UNITED STATES PATENT AND TRADEMARK OFFICE

APPLICATION NO.	FILING DATE	FIRST NAMED INVENTOR	ATTORNEY DOCKET NO.	CONFIRMATION NO.
10/690,080	10/21/2003	Ching-Hui Chi	2001064	4884

Office Action Summary

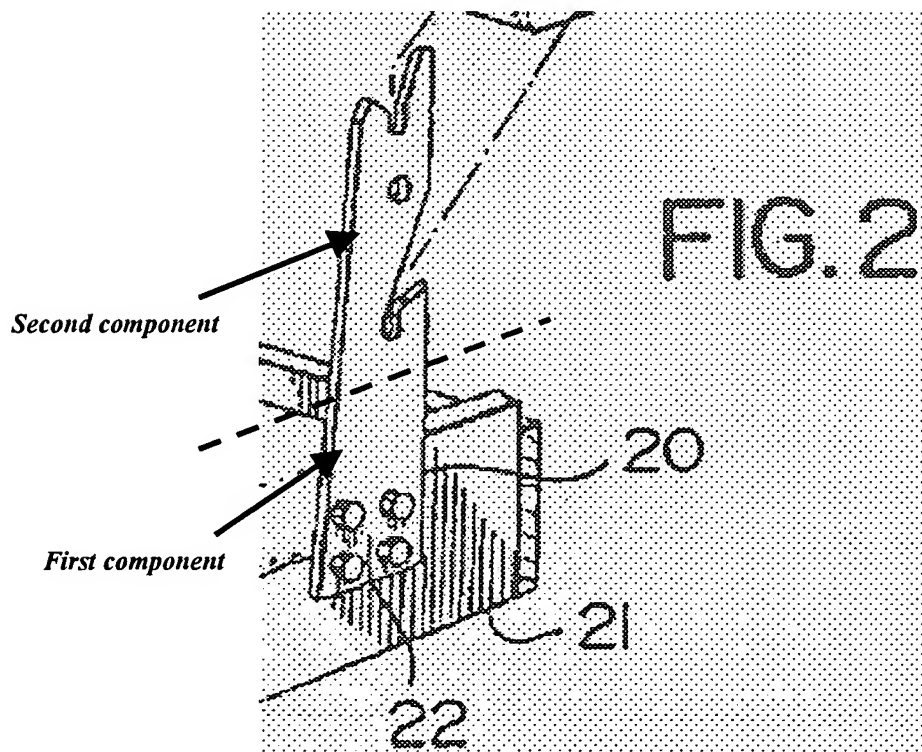
Boycott discloses a “furniture coupling system and method” comprising a pair of first supporting members 33 installed on both sides of the chair back, a pair of second supporting members 34 installed below the first supporting members on the chair back and a pair of supporting plates 20, which engage the first and second supporting members. Boycott’s supporting plates 20 can be divided into two components, as seen

below. The first component includes at least one locking hole 22 for being fixed to the chair base 21. The second component includes a first concave portion cooperating with the first supporting member 33 and a second concave portion cooperating with the second supporting member 34. The first concave portion is located at an end opposite to the connection between the first and second component. The second component is located opposite to the first side. Furthermore, the second component includes a second locking hole 44 “for attaching the back 31 to the base 21 of the seating furniture” (col.3, lines 40-41). Crum discloses a mounting bracket 20 having a lower portion 30 “for attaching the mounting bracket 20 to the base 5” and an upstanding link portion 33, “which is tapered toward its upper end” (col.3, lines 30-35). The figures disclose the “tapering” to be greater than 0 degrees and less than 180 degrees between the two components 30 and 33. However, both Boycott and Crum fail to expressly disclose a foot-raising mechanism or the material with which the supporting plate is made. Yet, May teaches of a similar supporting plate 166 with first and second components and first and second concave portions on the second component. May further teaches of a leg-raising mechanism. Furthermore, May discloses, “the chair of the invention may be manufactured of conventional materials...the mechanism may be largely made...from steel plate” (col. 2, lines 45-48). It would have been obvious to one having ordinary skill in the art at the time the invention was made to modify the seat of Boycott and Crum with a leg-raising mechanism and have material made of conventional materials, as taught by May, to provide a more comfortable and sturdy seat. Note: as disclosed in the present application,
